Miami Valley Hospital

Enclosed is our reponse (in duplicate) to your letter of February 20, 1987 requesting more information for our current amendment request to our License No. 34-00341-06, Control No. 81304. The enclosed information is numbered according to the questions of the February 20, 1987 letter.

ADDITIONAL INFORMATION TO THE
APPLICATION FOR CUSTOM MADE DEVICE, REQUESTED 20 FEBRUARY 1987

ISOTOPE CT SCANNER

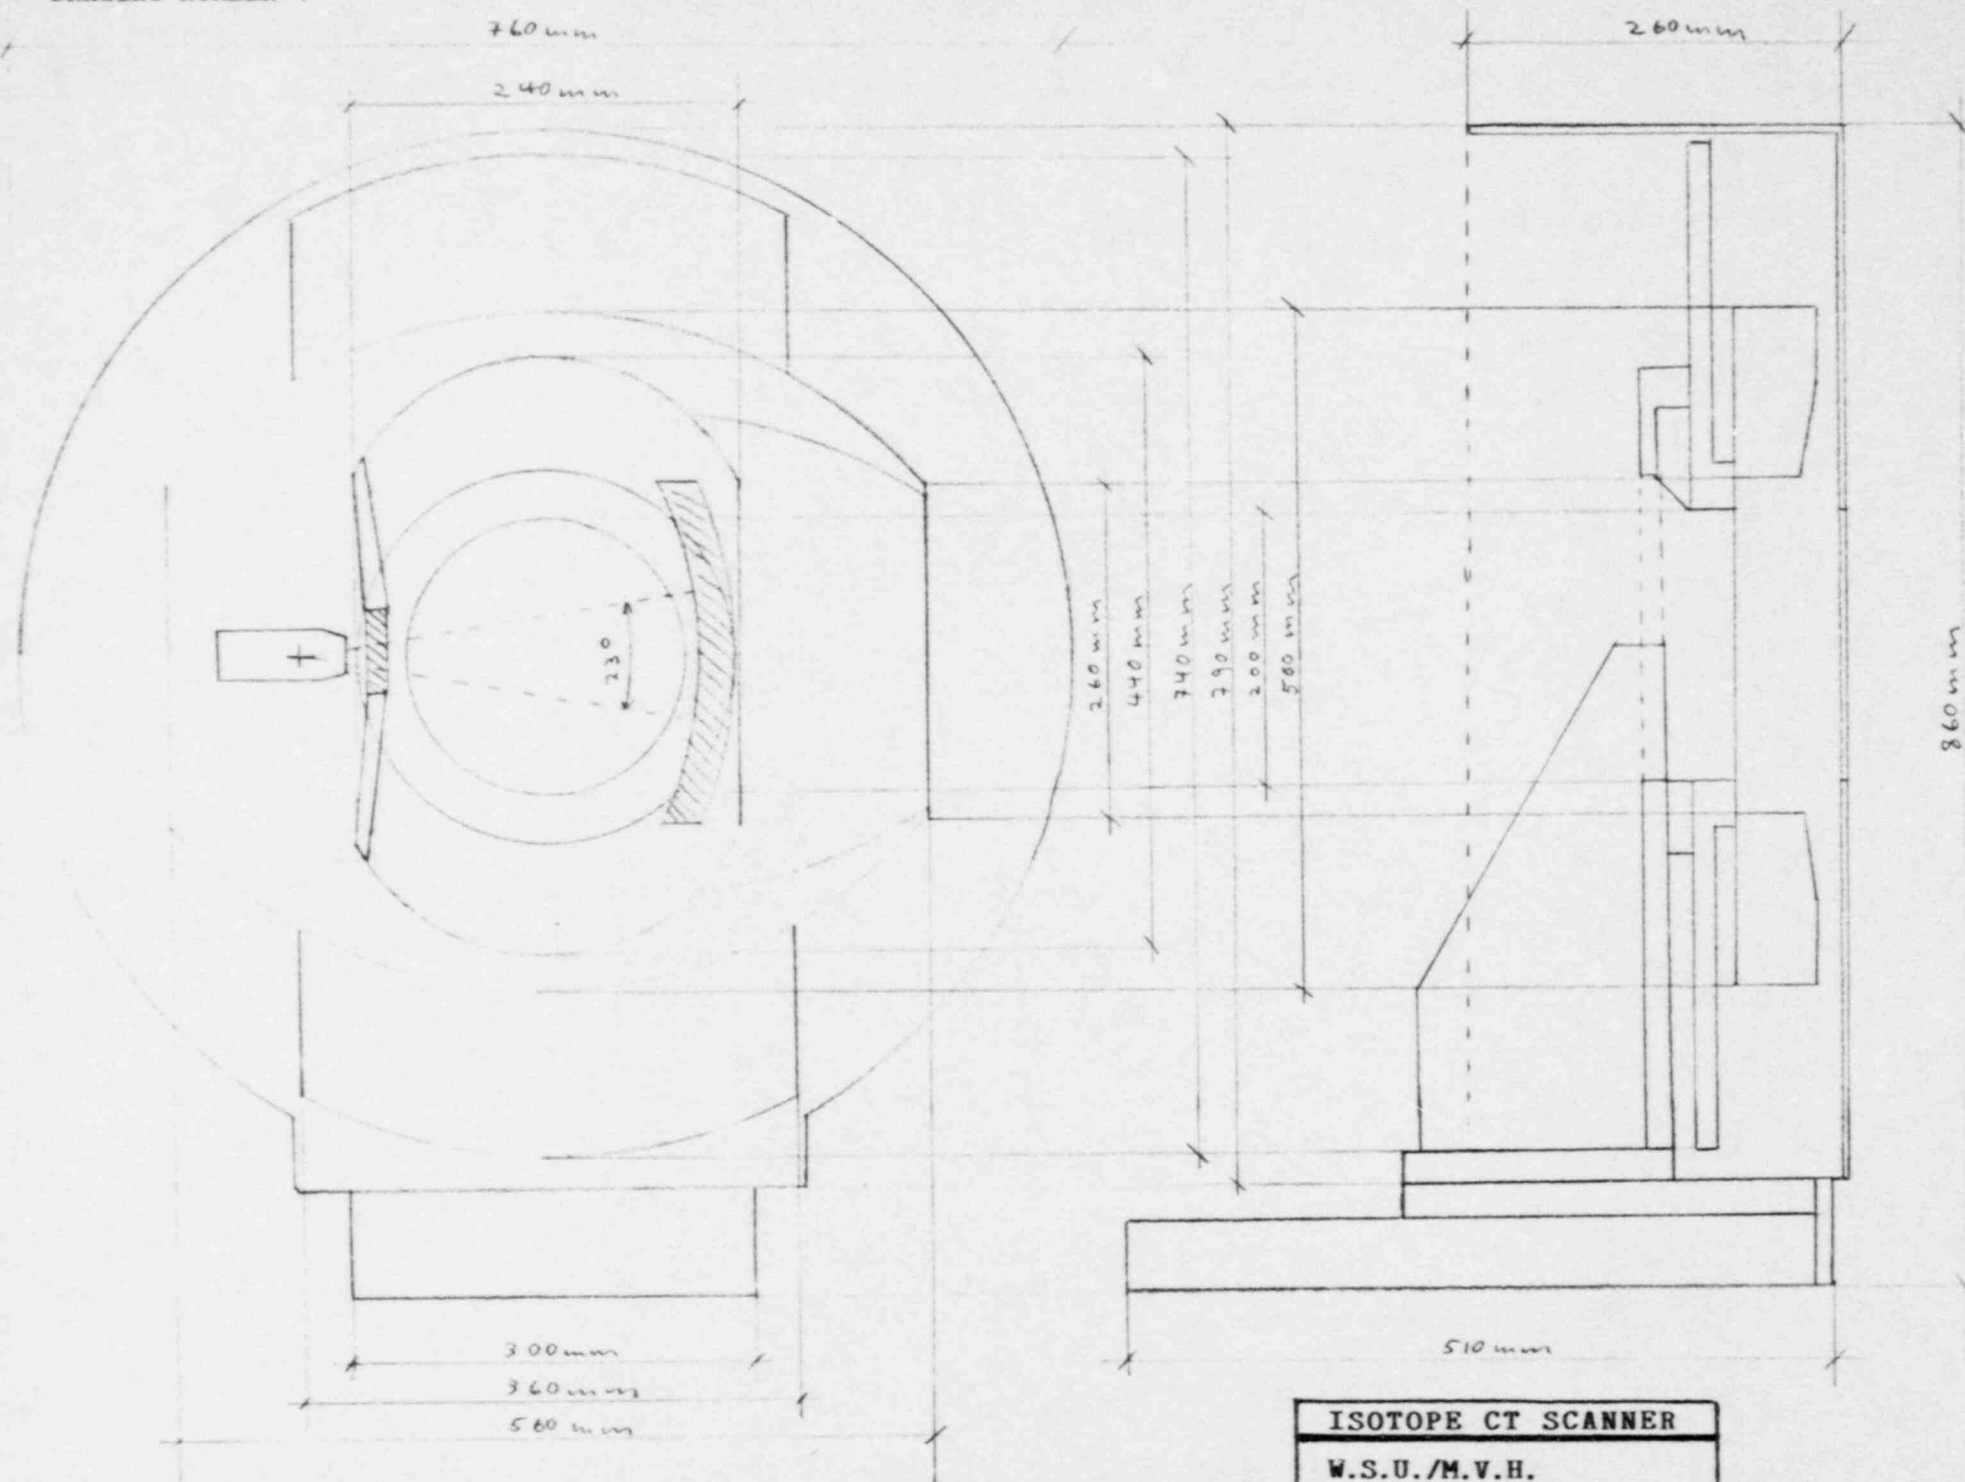
2.
 - a. Drawing #1.
 - b. Construction Material: Aluminum alloy for most of the machined parts, steel for gliding and rotational gear system, fiberglass for cover.
 - c. Shutter Placement on Source Holder: Drawing #2.

DRAWING NUMBER 2

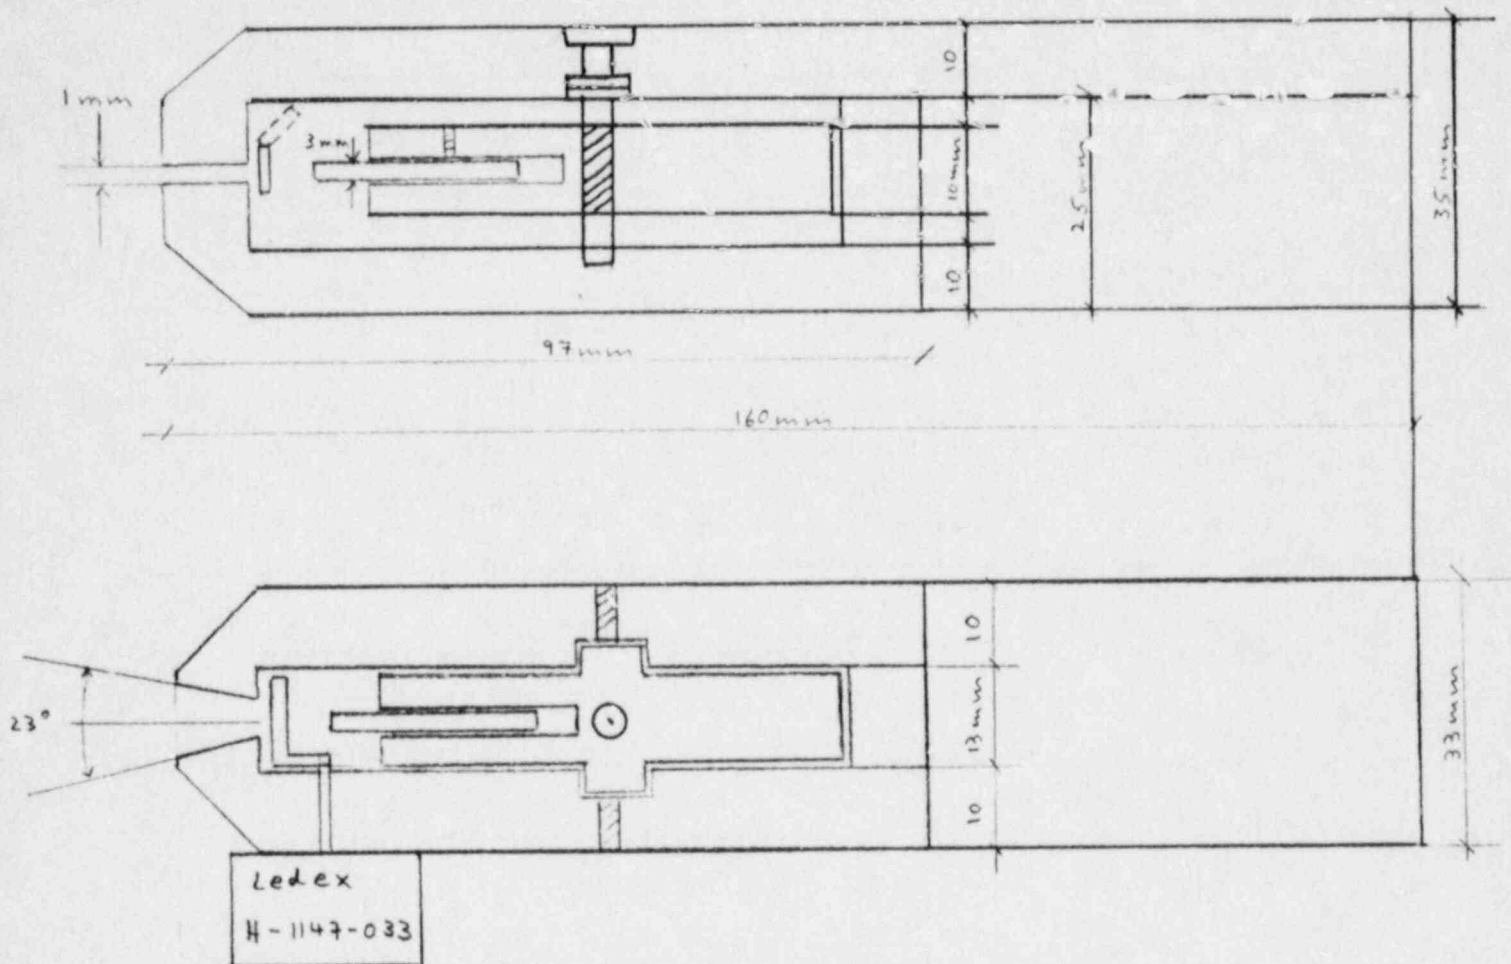
Shutter Operation: The shutter is opened by applying power to the rotary solenoid. If power is lost, the solenoid closes by spring action. The electronic system that actuates the shutter works in the following way:

Immediately before a scan with data collection is initiated, the software issues a command to open the shutter. This command produces a 0.5 s pulse on a monoflop. If the stepping motors are started through further computer commands, the shutter is kept open for another 0.5 s for each stepping-motor pulse issued. When the scan is finished, or for some reason the communication between scanner and computer is interrupted, the shutter will be closed within 0.5 s automatically. For service operation, the shutter can be opened manually.
 - d. On-Off Indicators: A warning light is placed on the scanner cover indicating, when on, that the shutter is open.
 - e. No additional interlocks or guards apart from Item c are foreseen.
